HISTORIC AND DESIGN REVIEW COMMISSION

HDRC CASE NO: 2017-118

ADDRESS: 503 E MYRTLE

OWNER: Larkin and Rachel O'Hern
TYPE OF WORK: Construction of rear addition

2 NEW FRONT ELEVATION

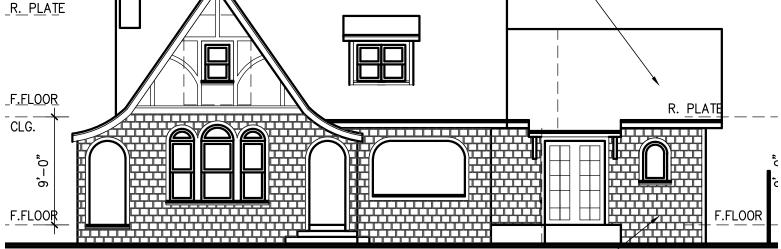
- e. FRENCH DOORS The applicant has proposed to install French doors on the front façade of the new addition. Staff finds the proposal to add French doors acceptable but requires more information on material, profile, muntin details, and manufacturer.

- i. Existing wood windows be salvaged and reused in the addition. The applicant can work with staff to determine the most appropriate and feasible locations for salvaged windows.
- ii. The applicant provides staff with specifications of the proposed French door for approval.
